# Access Compliance Report

## Public Rights-of-Way (Curb Ramps)

Intersection ID: 10022801	Main Street: CASCADE_POINTE_BV	Cross Street: N/A	Location: SW
ADA ID: 64627F9103D4	Ramp Type: ParaDiag	Initial Pass/Fail: Fail	Overall Compliance: No
		Severity Score: 12.5

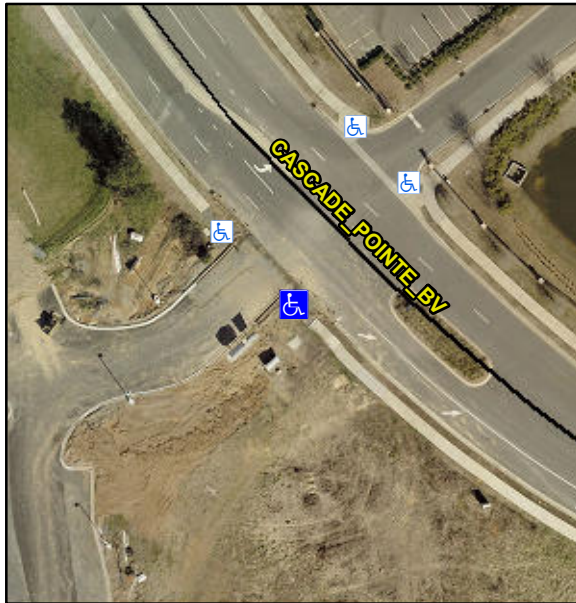
Compliance	Description	Data	Compliance	Description	Data
N/A	Ramp Length LT (in)	35.0	N/A	Ramp Length RT (in)	72.0
Yes	Ramp Width LT (in)	86.0	Yes	Ramp Width RT (in)	66.0
Yes	Ramp Slope LT (%)	7.2	No	Ramp Slope RT (%)	8.6
Yes	Ramp XSlope LT (%)	0.6	Yes	Ramp XSlope RT (%)	1.4
N/A	Landing Length (in)	N/A	N/A	DWS Provided?	N/A
N/A	Landing Width (in)	N/A	N/A	DWS Contrast?	N/A
N/A	Landing Slope (%)	N/A	N/A	DWS Length (in)	N/A
N/A	Landing X Slope (%)	N/A	N/A	DWS Full Width?	N/A
N/A	Landing Curb? (Y/N)	N/A	N/A	DWS Offset (in)	N/A
N/A	Shared Landing?	N/A			
N/A	Gutter Ponding?	N/A	N/A	Gutter Slope (%)	N/A
N/A	Gutter Lip Ht (in)	N/A	N/A	Gutter X Slope (%)	N/A
N/A	Painted X Walk1?	No	N/A	Painted X Walk2?	No
	X Walk 1 Direction	To NE		X Walk 2 Direction	To NW
N/A	X Walk 1 Width (in)	N/A	N/A	X Walk 2 Width (in)	N/A
	X Walk 1 Slope (%)	4.3		X Walk 2 Slope (%)	1.6
	X Walk 1 X Slope (%)	1.7		X Walk 2 X Slope (%)	3.7
N/A	Ramp inside XWalk1?	N/A	N/A	Ramp inside XWalk2?	N/A

Road Slope (%)	1.0	N/A	Clear Space?	N/A
	Road X Slope (%)	5.2	N/A	Clear Space to XWalk (in)	N/A
N/A	Any Obstructions?	N/A	N/A	Storm Grate/Utility Hazard?	N/A
	Obstruction Type			Storm Grate/Utility Type	
		N/A			N/A
			Yes	Surface Condition? (G/P)	Good
			N/A	Curb Slope (%)	12.5

**Remove & Replace Curb Ramp With Two New Directional Ramps or Equivalent.**

**R304.3.2**
